**ARLINGTON COUNTY, VIRGINIA  
AGREEMENT No. 20-110-9-6**

**AMENDMENT NUMBER 2**

**Ballston-MU Station Area Improvements Project  
MEMORANDUM OF NEGOTIATIONS**

**CHANGE ORDER No. 4 – Add one (2) new item: Materials Cost Difference for Planter Wooden Benches and Adjust Sanitary Manhole; removing of (6) existing items from Pay Item list.**

A3.11

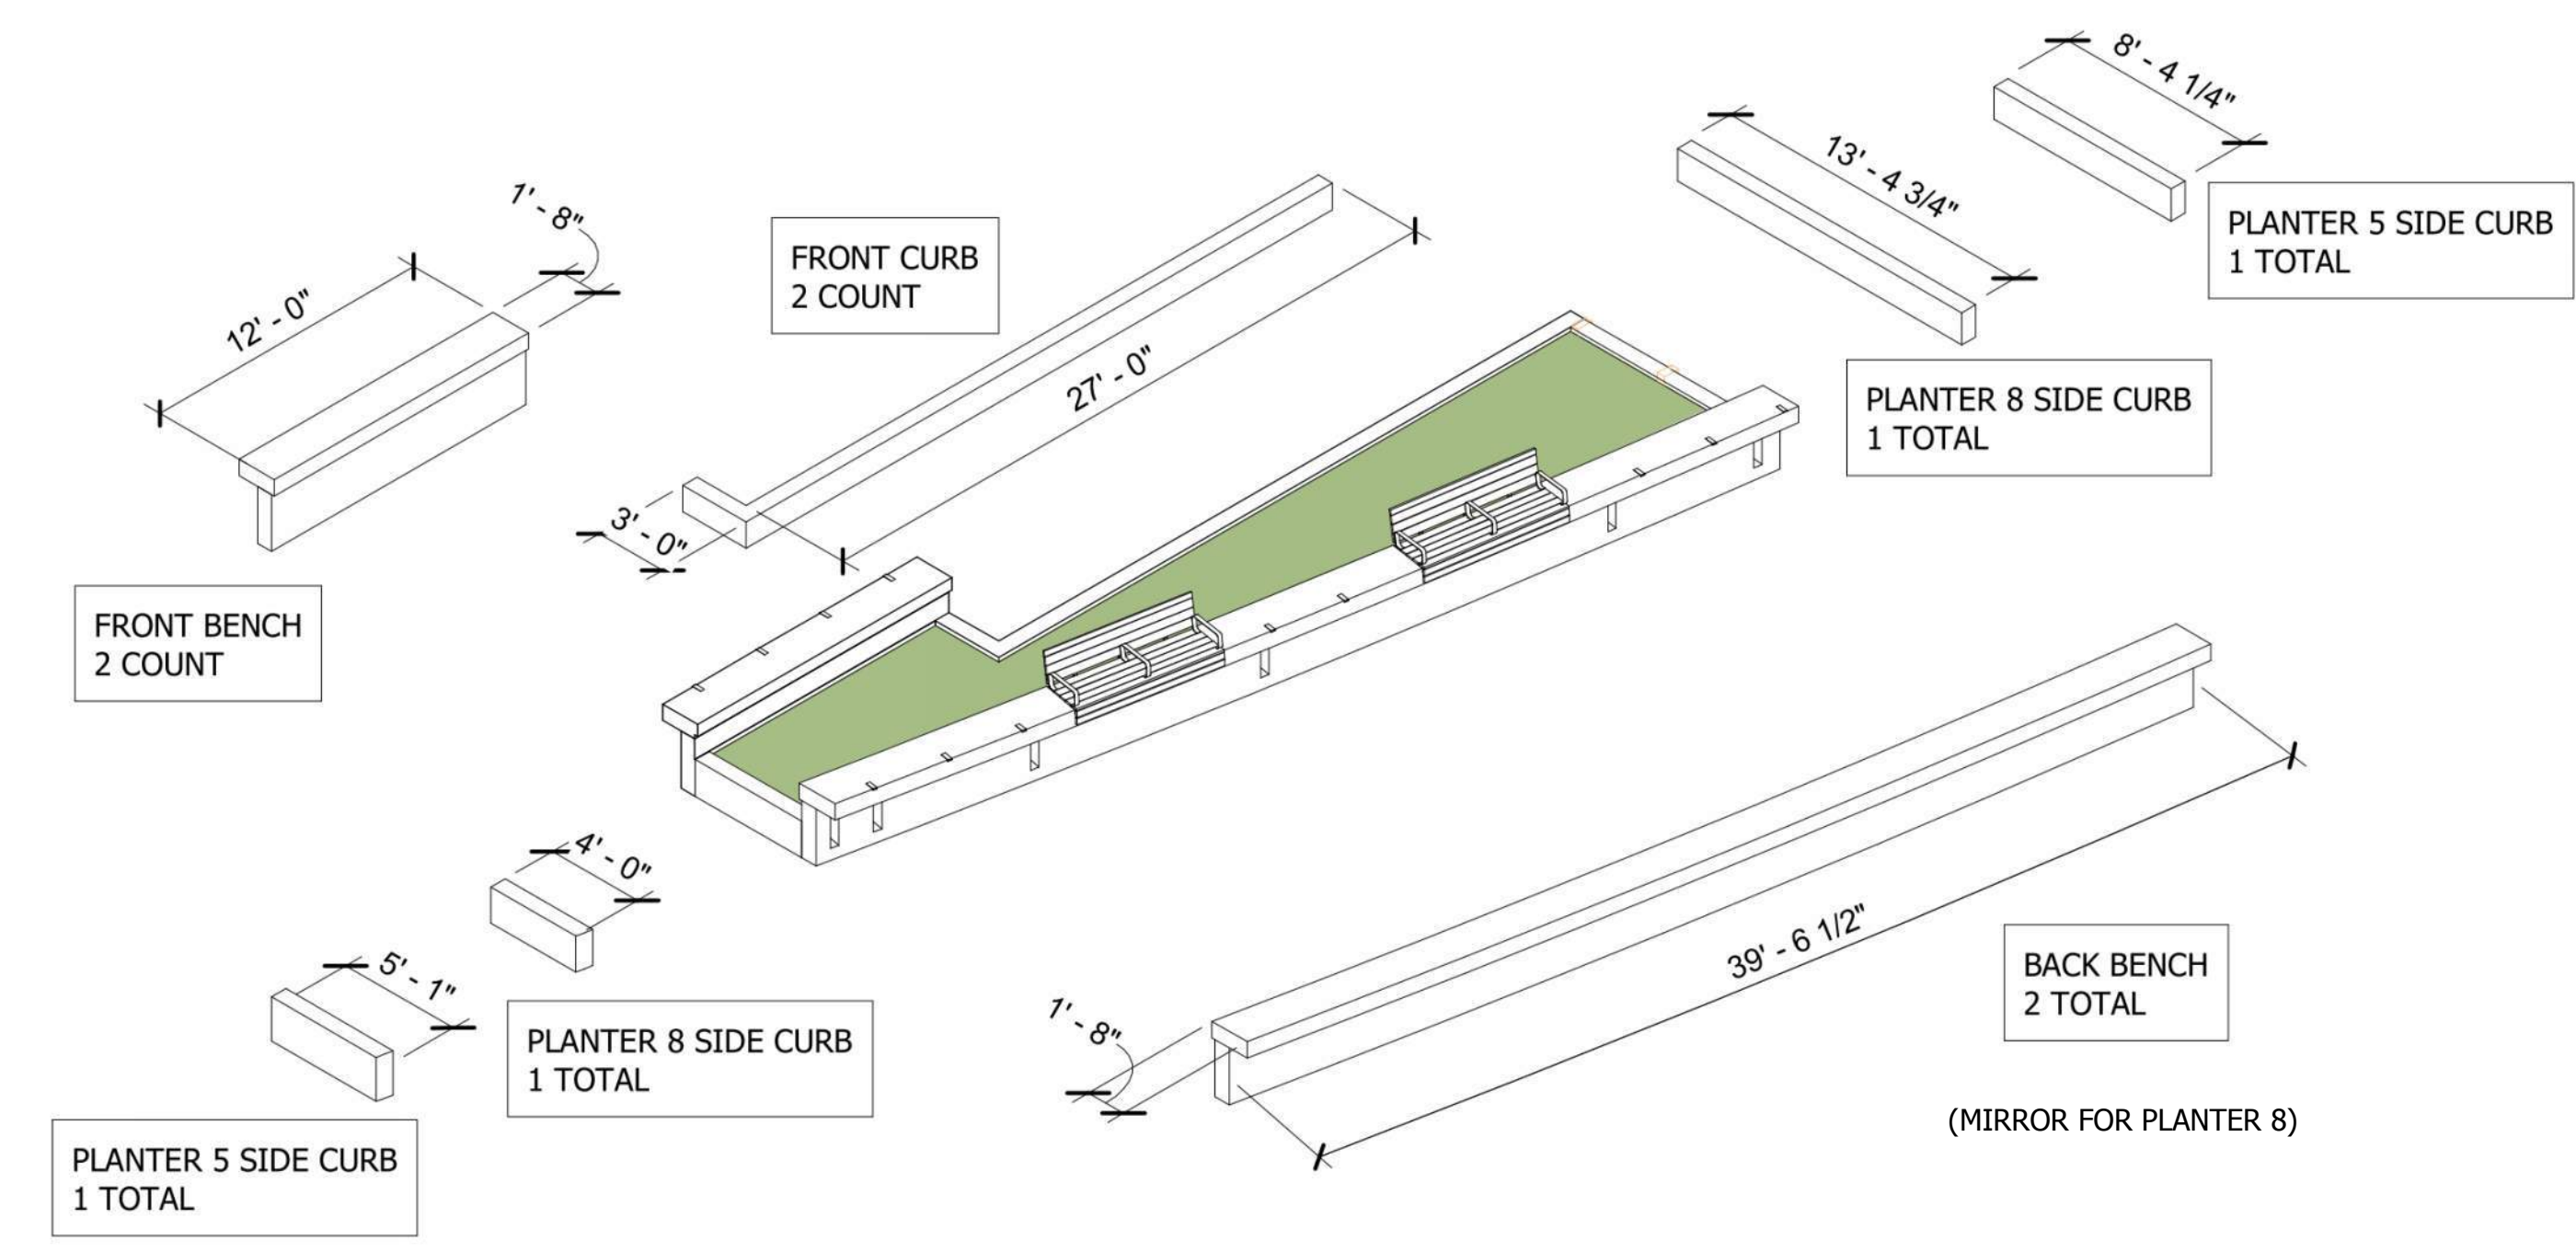
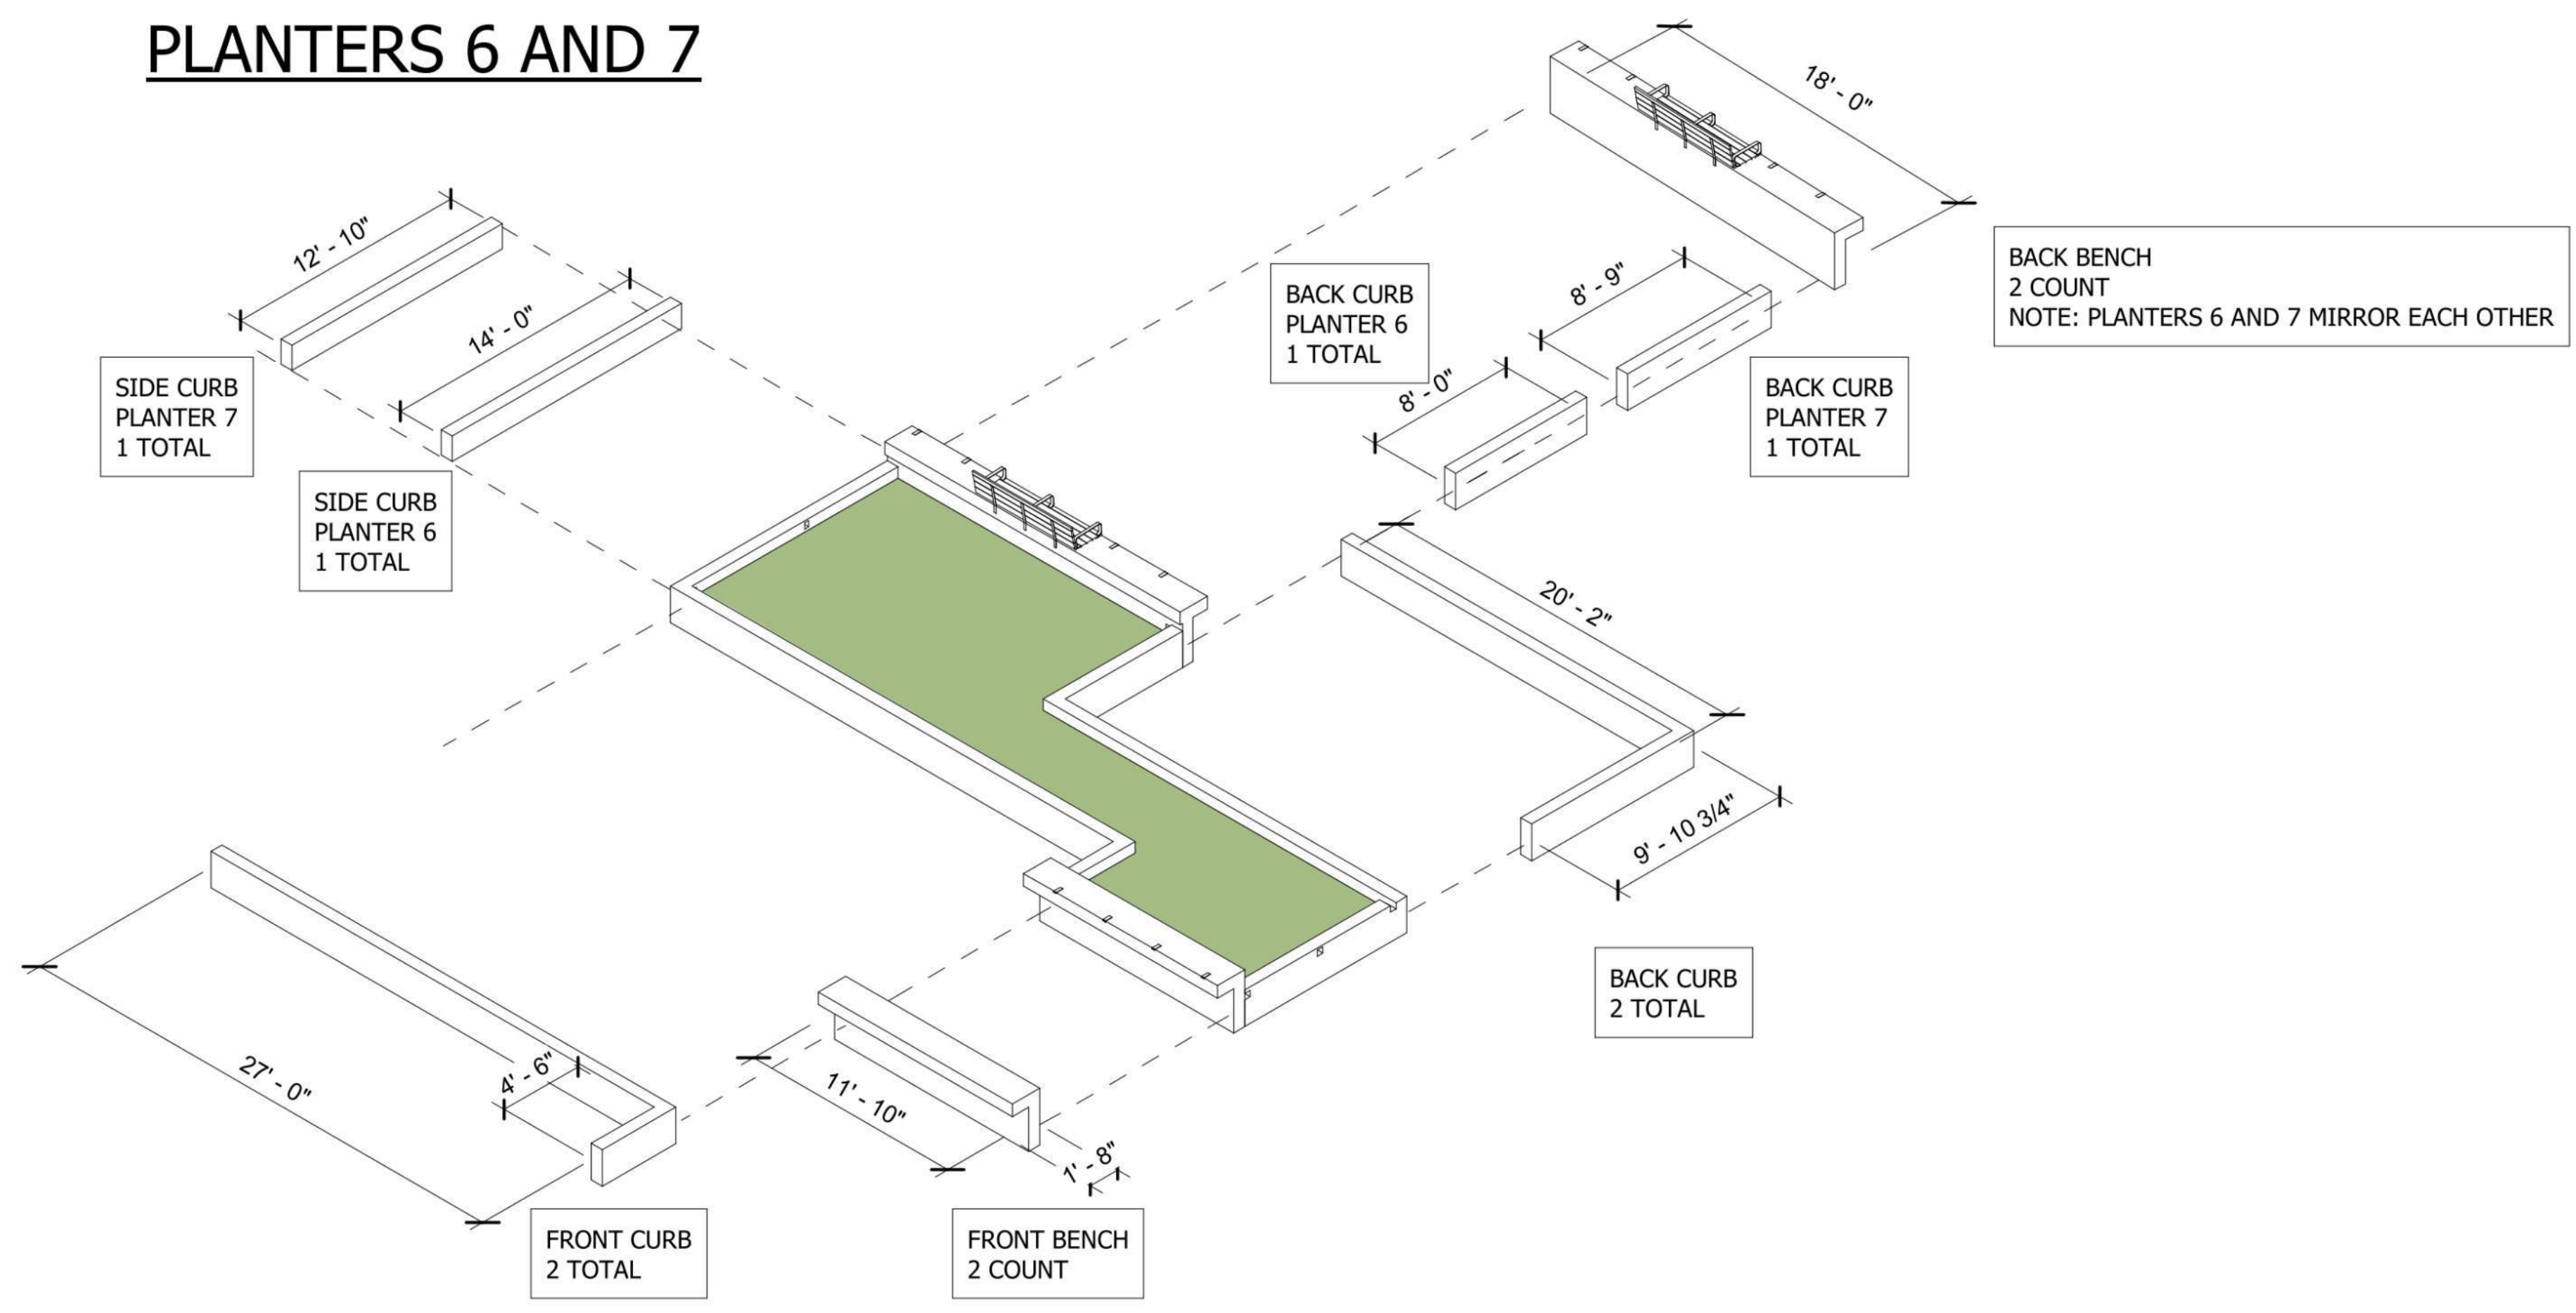
- Reason for Change Order: Due to the redesign of N. Stuart St. after the start of construction, a hold was placed on releasing the subject benches for manufacture until the redesign was finalized in July 2021. As a result of the expiration of the original bid quote dated 8/14/20 and the subsequent cost quote dated 1/7/21 and an increase in the cost of raw materials, Ardent submitted a new quote and resultant Change Order on 7/16/21 for the materials cost difference to procure Bid Item No. 113 – Planter Wooden Benches which are an alternate to the original Escofet Universe System benches.

Ardent Company hereby submits a change order request to compensate for the price difference for the procurement of wooden benches in planters alternate to the Escofet Universe System benches.

Based upon the findings, it is recommended that a change order be issued to Ardent for a lump sum amount of \$45,053.50. The following find the price to be fair and reasonable for the work involved.

**1 LIGHT POLE FOOTING - SECTION**  
3/4" = 1'-0"

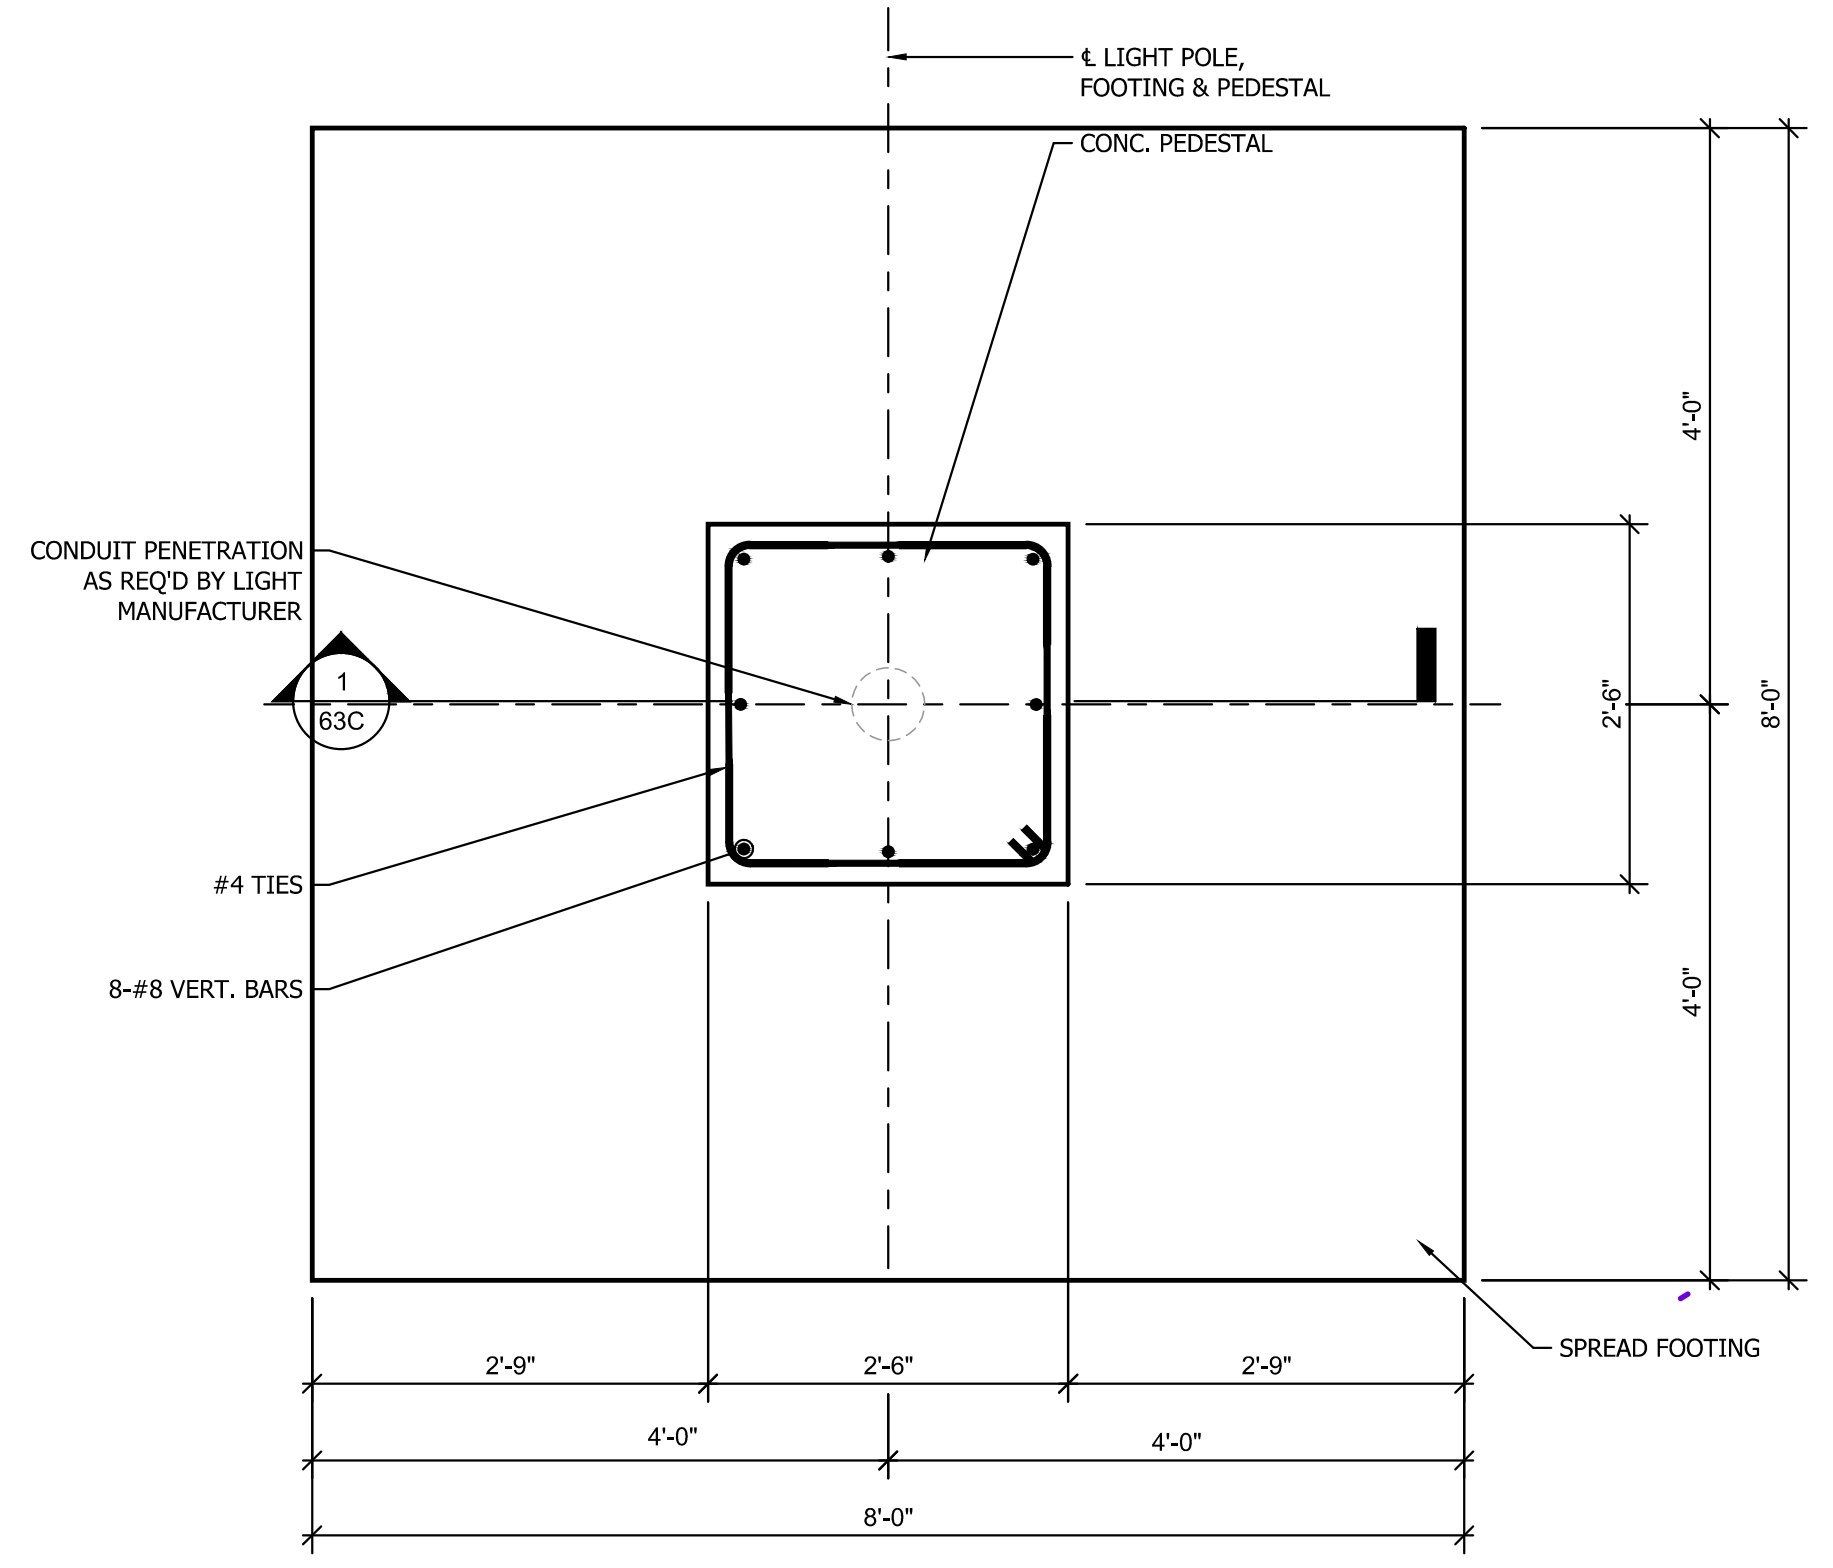
- Reason for Change Order: Due to the close proximity of the 901 N. Stuart St. parking garage roof deck slab to the sidewalk surface between 9<sup>th</sup> St. and Fairfax Dr. within the Phase 2 limits, the 8 streetlight foundations cannot be constructed per Arlington County standard depths so spread foundations were designed as part of the NSSR and a price proposal was requested from Ardent for the revised design
- Negotiation Recap: Held 09/28/21: Bijay Subedi (PM) Ardent (Contractor); Alfonso Ronca (PM) and Sekander Salihi (RE) representing Arlington County met virtually and presented each party's estimate for this item: Arlington County Estimate (ACE = \$4,494.00 EA; Contractor's Proposal (CP) = \$6,518.00 EA.

Based on these acknowledgements, the CP and ACE agreed: to compromise midway on the labor hours required (12 hours) for (1) unit of spreader streetlight foundation and agreed on to add (1) service truck for 12 hrs. As result, the parties agreed that vendor quotes would be used for the rebar and anchor bolts estimate. As result, the parties arrived at a unit price of \$5,913.00 for each spread footer modification for a total of \$47,304.00 for 8 spreader streetlight foundations.
